RECEIPT DATE: 10/12/17 **ONSITE SEWAGE DISPOSAL SYSTEM** P 561548

From: Oswald, Hank
Sent: Monday, March 06, 2017 11:52 AM
To: lalexander@clsimail.com
Subject: 13951 Hallowell Court_OSDS Plan Comments

I reviewed the OSDS plan for 13951 Hallowell Court with the following comments:

ONSITE SEWAGE DISPOSAL
SYSTEM DESIGN PLAN
TRIADELPHIA MILL FARMS
SECTION 1, AREA 2
LOT 6
13951 HALLOWELL COURT
5th ELECTION DISTRICT, HOWARD COUNTY, MARYLAND ZONE: RC-DEO
PLAT C.M.P. NO: 4901, TAX MAP: 28, GRID: 19, PARCEL: 138

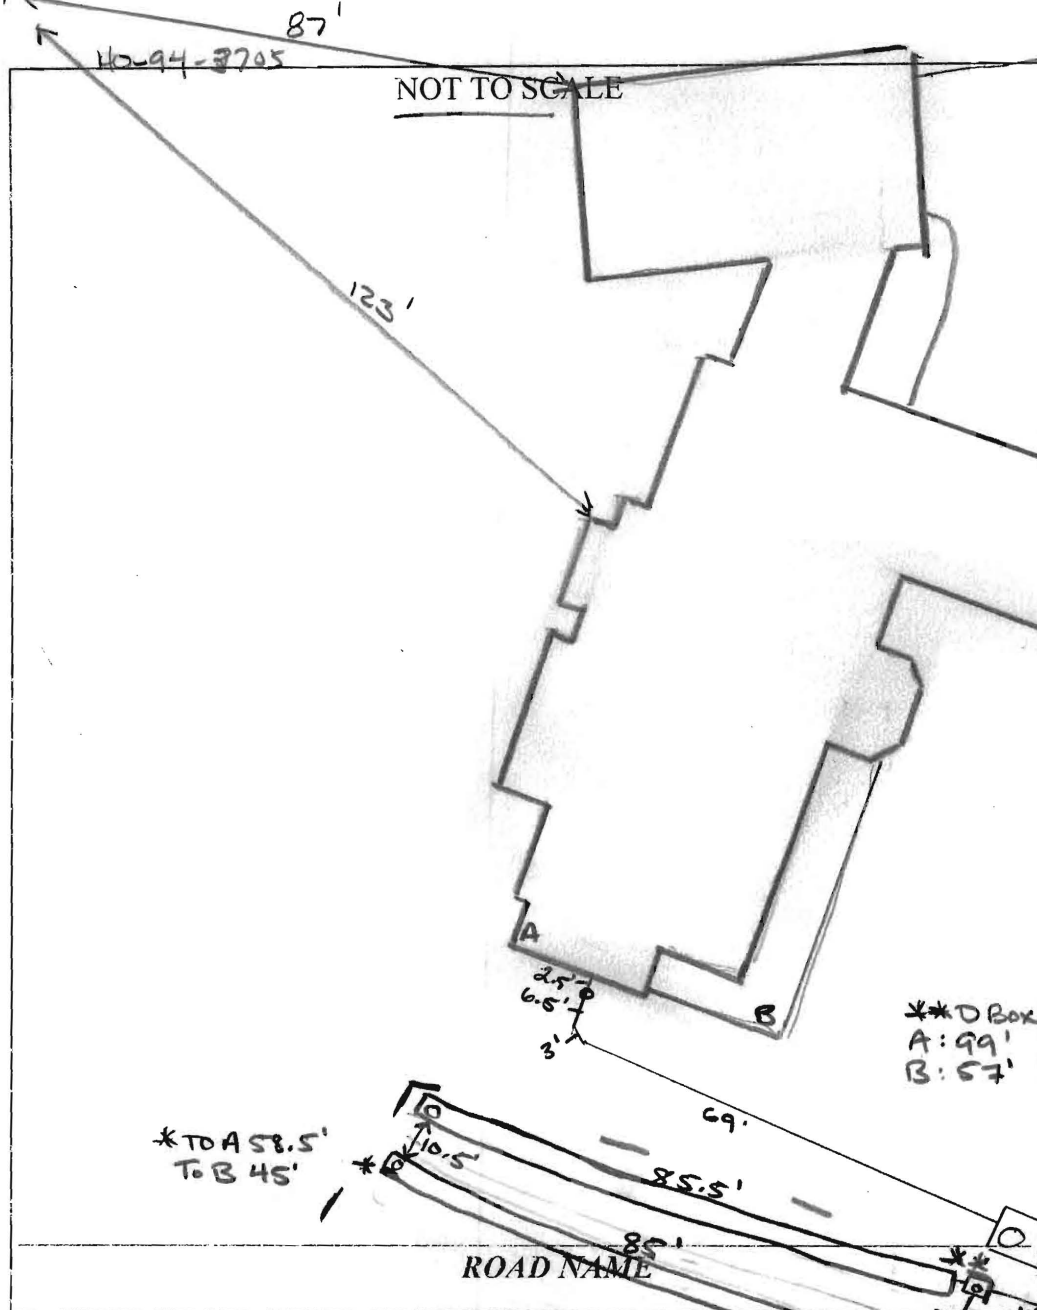
TRENCHES:	LINEAR FEET REQUIRED: <u>128 170</u>	INLET DEPTH: <u>3 3.5'</u>
	TRENCH WIDTH: <u>2</u>	MAXIMUM BOTTOM DEPTH: <u>7'</u>
	MINIMUM SPACE BETWEEN TRENCHES: <u>10 9</u>	EFFECTIVE AREA BEGINNING DEPTH: <u>4</u>
LOCATION:	PER APPROVED SITE PLAN. SEWAGE DISPOSAL AREA AND TANK LOCATIONS MUST BE STAKED BY LICENSED SURVEYOR PRIOR TO PRE-CONSTRUCTION INSPECTION.	
NOTES:	Install 2 x 85' trenches on contour to best fit and conserve area for future SOA repl. - <u>Kmw</u>

10/16/17 Adjusted specs to better fit inside proposed SOT. moved tank slightly downhill from proposed location, to avoid fall shown on ODS plan call for inspection. 2 x 85' trenches
 INSTALLATION: running across top part of SOT w/ in 2"-4". (mm)

10/17/17 Installed Tank and lower trench. Ok to backfill (D)
 10/18/17 Completed upper trench, checked speed level of D Box. Ok to backfill. (D) SEWER LINE SPEC: 4" Silverline Coex Cellular Core PVC-Duv Pipe IPS SCH-40 Series [ASTM F-891-10 NSF-duv 10 Non Pressure SL-CM 10A

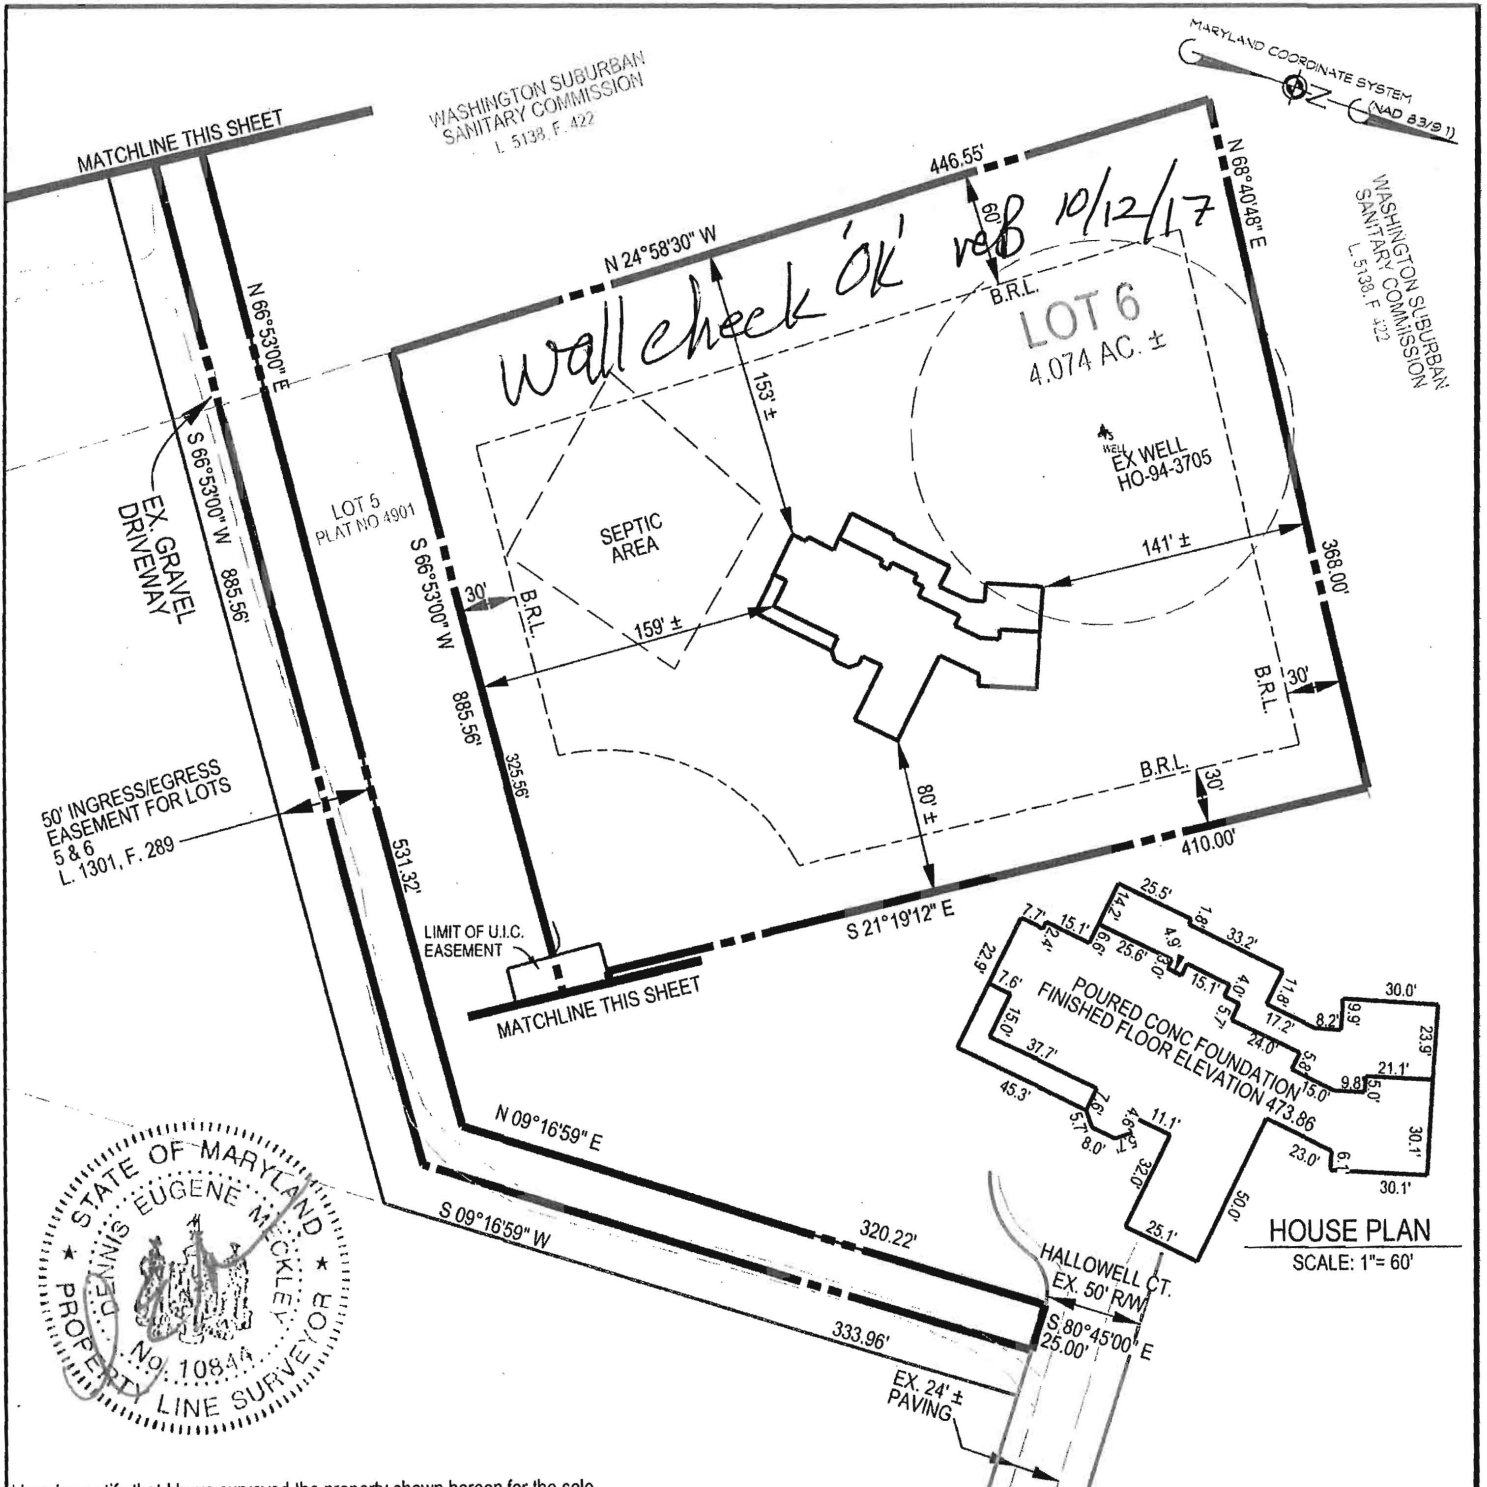
- 1.) Show 10 foot separation between all trenches on plan. Please note, minimum trench separation is 10 feet on all trenches utilizing sidewall reduction credit.
- 2.) Sidewall Reduction Credit should be $2+2/2+1+2(3) = 0.44$ (not 0.36)

Please revise the plan accordingly. Should you have any questions, please don't hesitate to ask.
